Supplementary Information

Presentation from Eugene Bourgeois and Anna Tilman

Bruce Power Inc. – Bruce A and B Nuclear Generating Station

Request for a ten-year renewal of its Nuclear Power Reactor Operating Licence for the Bruce A and B Nuclear Generating Station

Tritium – Historical Waterborne Emissions (Bq/yr)

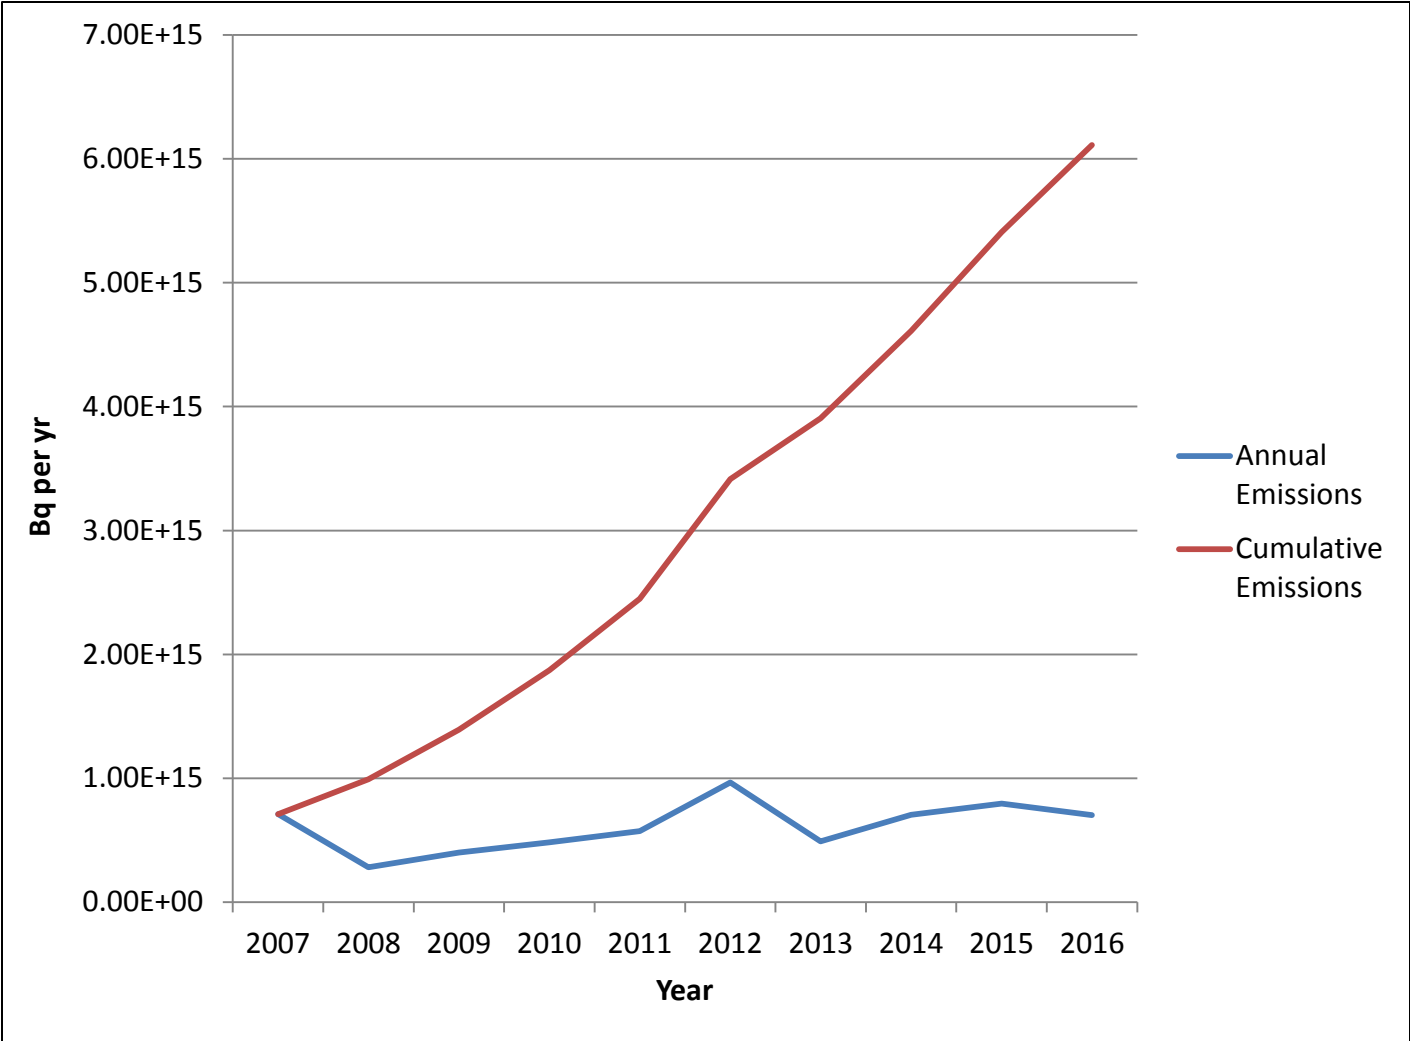
- **Airborne and Water effluent emissions:**
Bruce A & B, the Laundry Facility, and the WWMF:
 - Species of radionuclides monitored & reported
- **Tritium:**
 - Cumulative emissions
 - Foundation Drainage (Units 3 and 4)
- **Derived Release Limits & Action Levels – Effectiveness?**

Sources of Deuterium Uptake

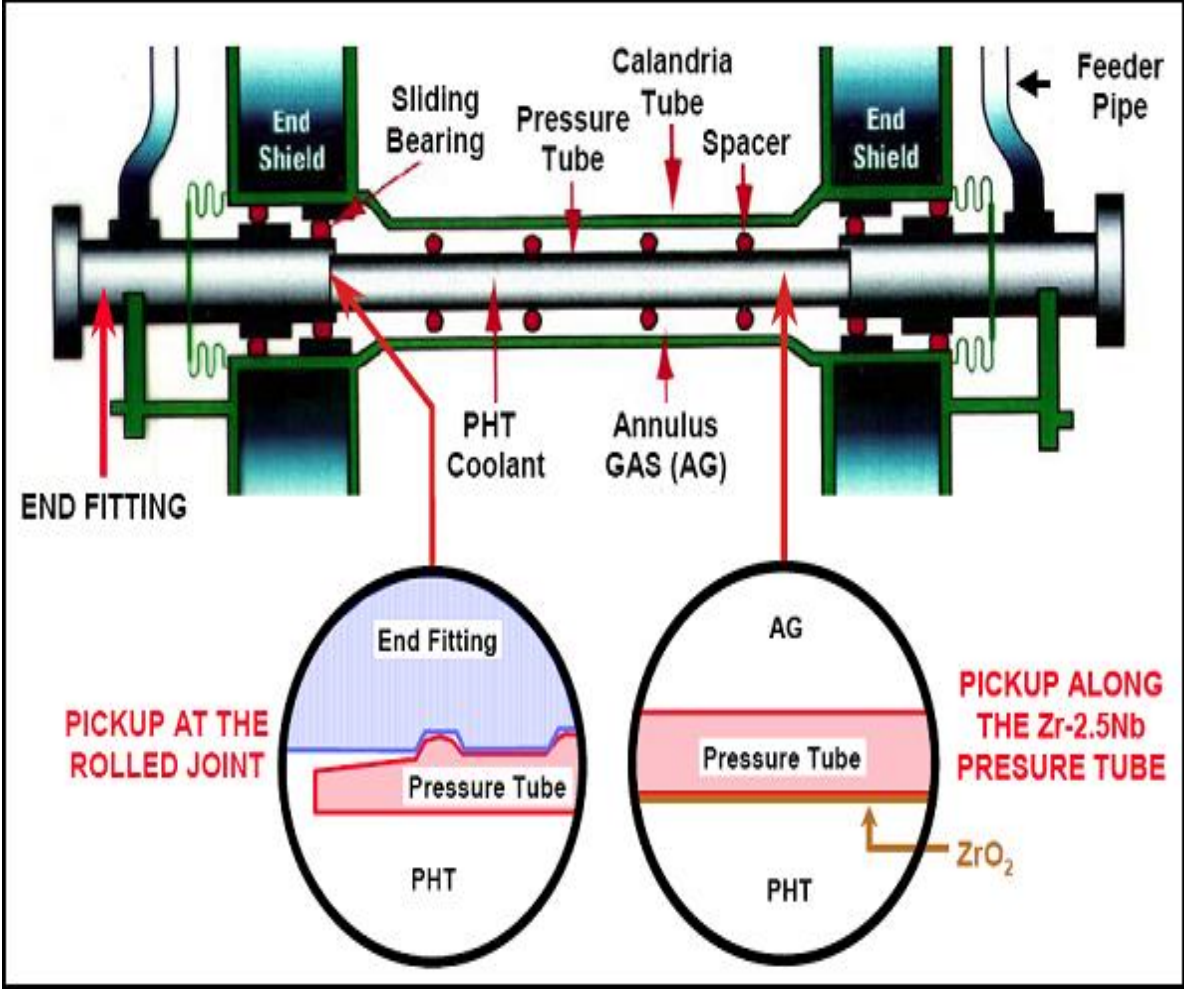
- **Fuel Channel Components**
 - Pressure Tubes: Hydride Formation, Deuterium Ingress (Heq), Material wear and fretting
 - Calandria Tubes, Feeder Pipes, Annulus Gas System
- **Outage Schedule**
- **Fitness for Service**
 - EFPH:
 - Operation beyond 247,000 EFPH
 - Units 3 and 4 Historic Performance
 - Hot Hours
- **Models and Tests – Effectiveness**
- **Safety Analysis - Methodology**
